Blackstone Models C-19 Wiring Diagrams

Tsunami² TSU-1100 upgrade

Replacement Tsunami², TSU-1100 Steam-2, Digital Sound Decoder:

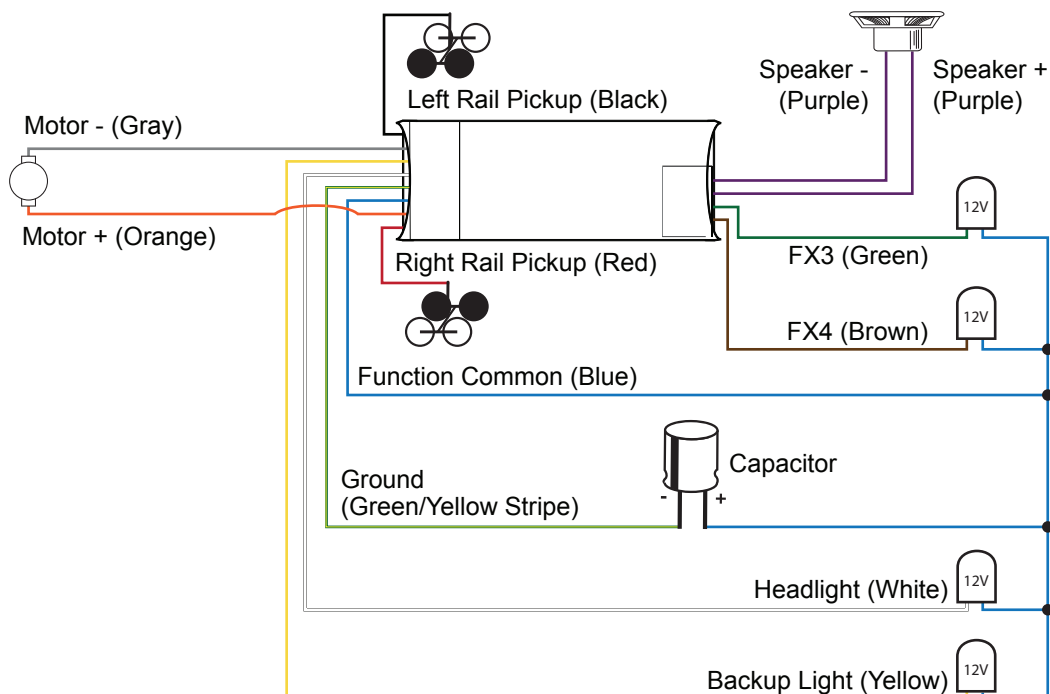
The Backup Light (Yellow), FX3 (Green), and FX4 (Brown) wires will not be needed in this installation. Trim them short, insulate the ends, and tape them back to the decoder.
